MEMORANDUM

CITY: City of Rollingwood

SUBJECT: 3225 Park Hills Drive and 601 Riley Road
Setbacks

DATE: August 17, 2022

601 Riley Road

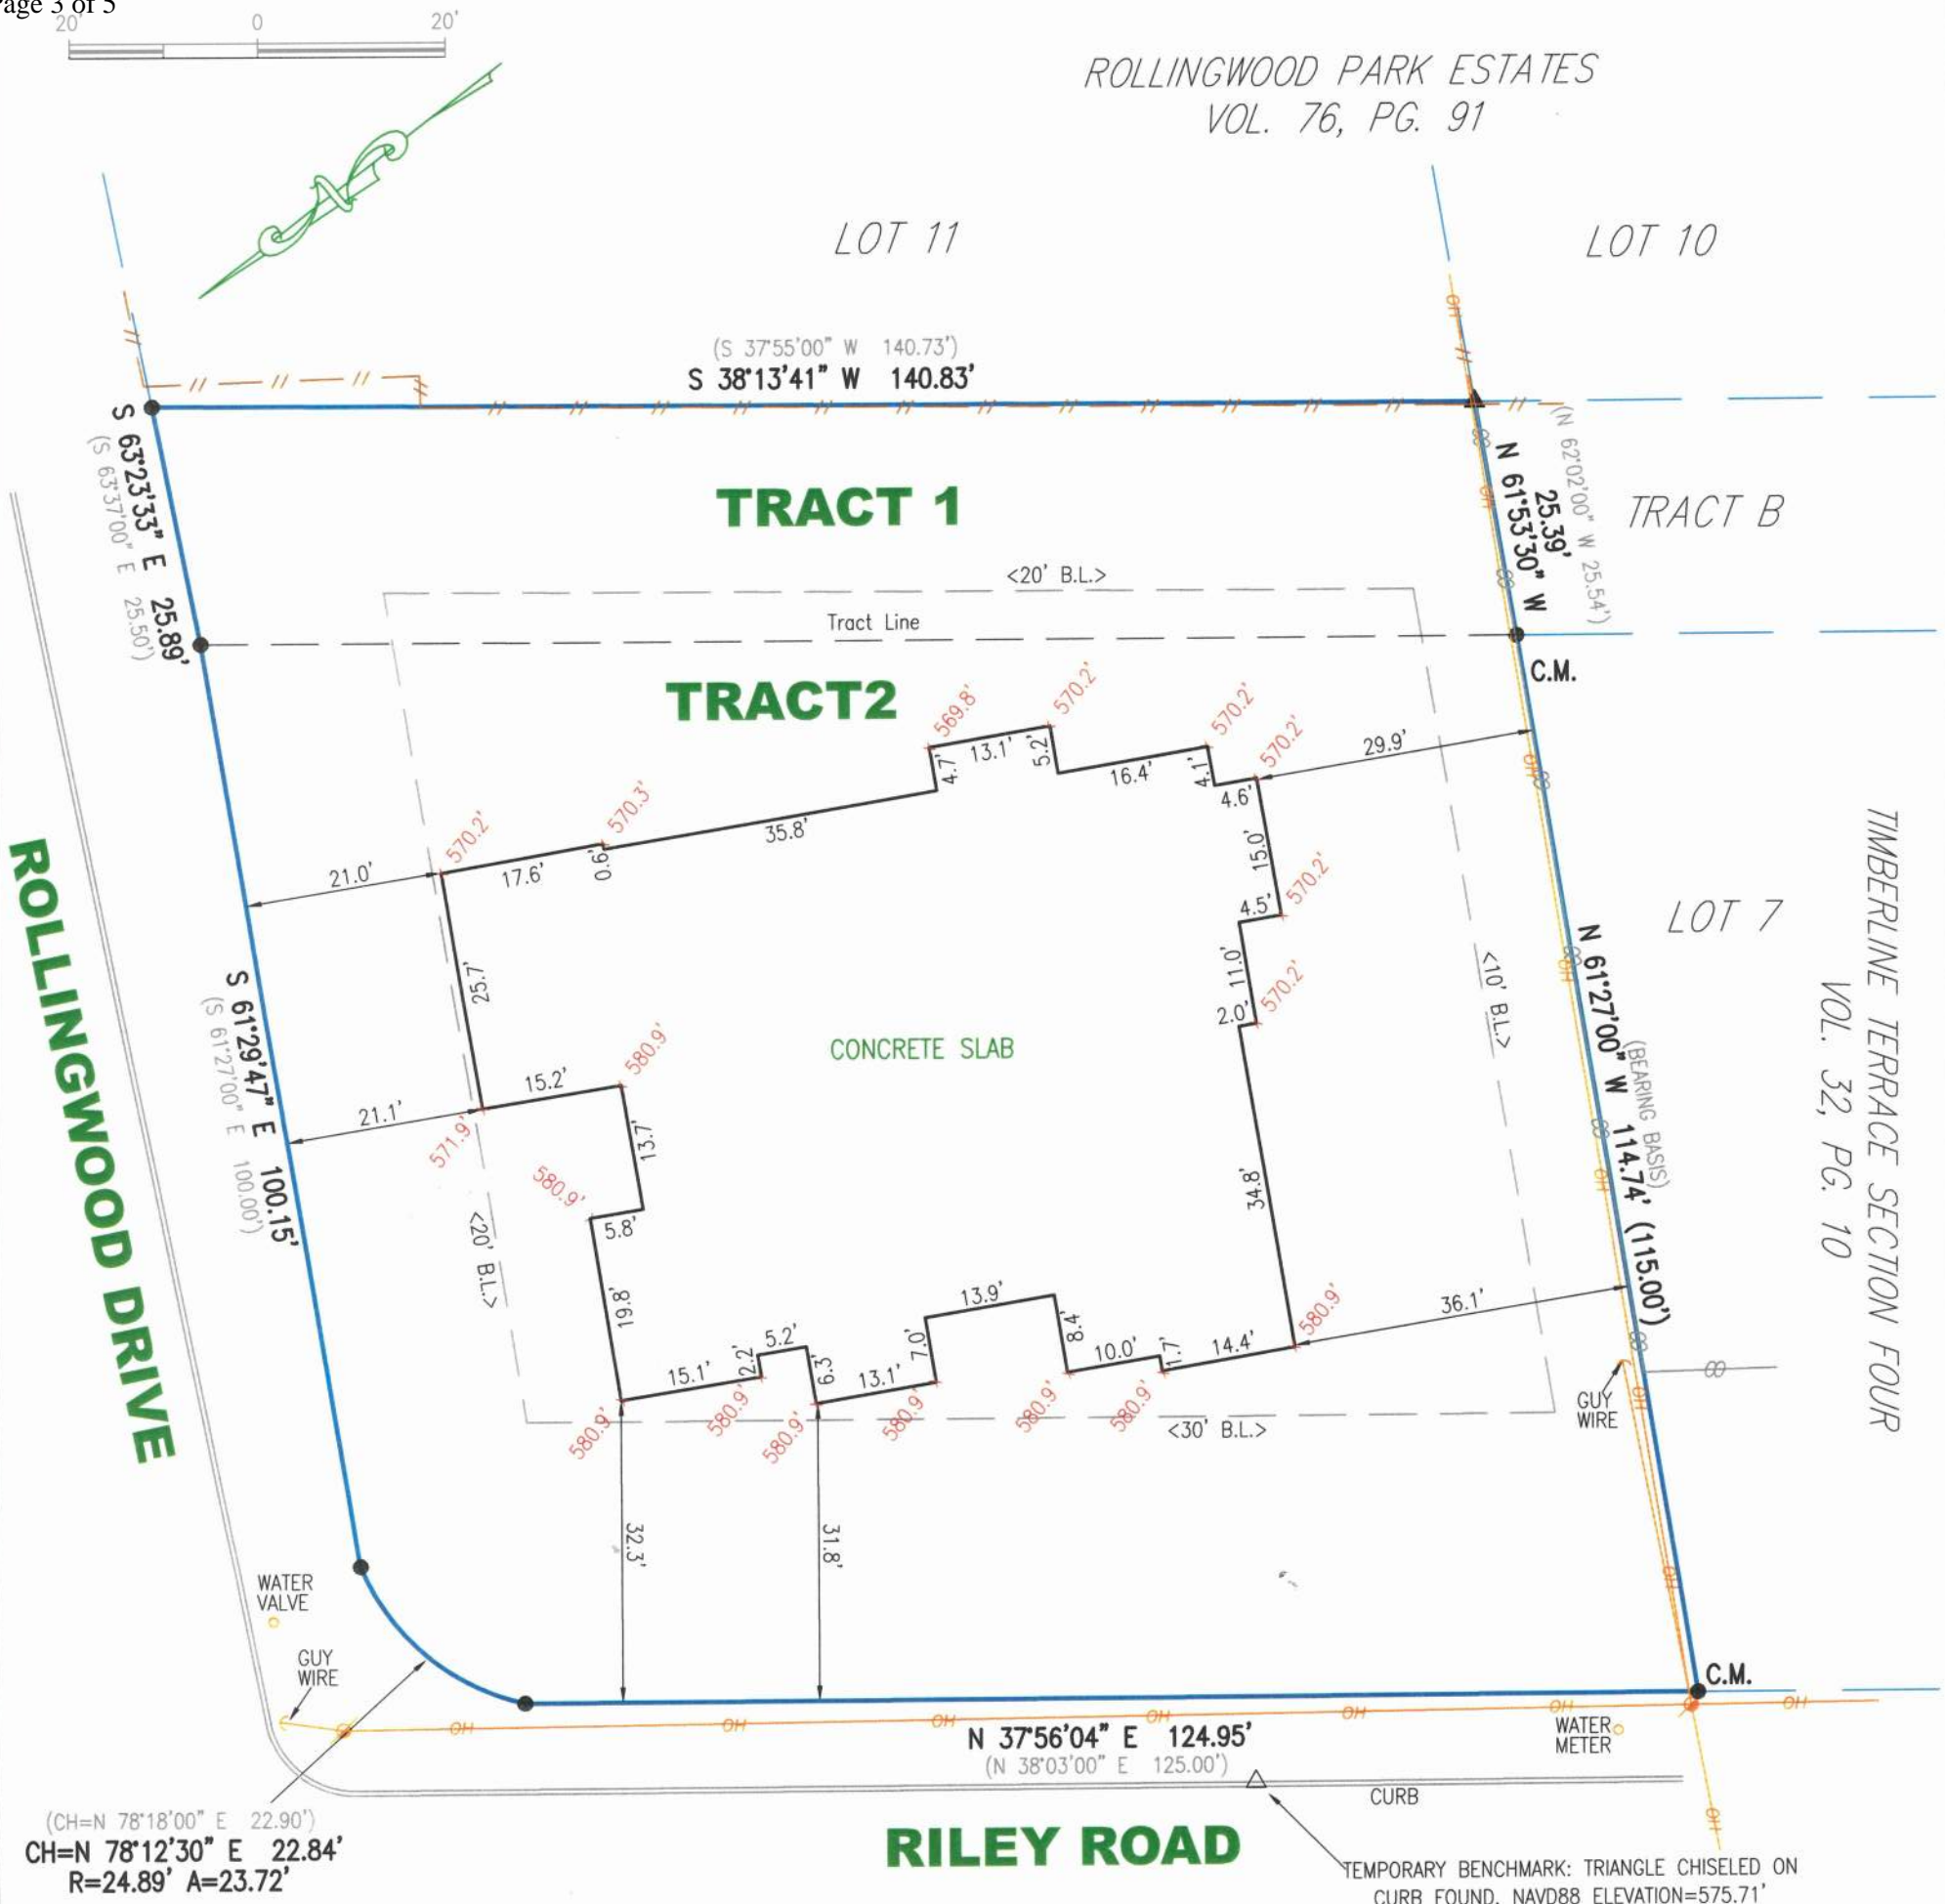
Based on the Survey below for 601 Riley the site is in compliance with Rollingwood Code Section 107-76, with a front yard setback of 30-feet per Section 107-76 (b), backyard setback of 20-feet per Sections 107-76 (d) and a minimum of 10-feet of side yard per Section 107-76 (c)(1) and 20-feet per Section 107-76(c)(3).
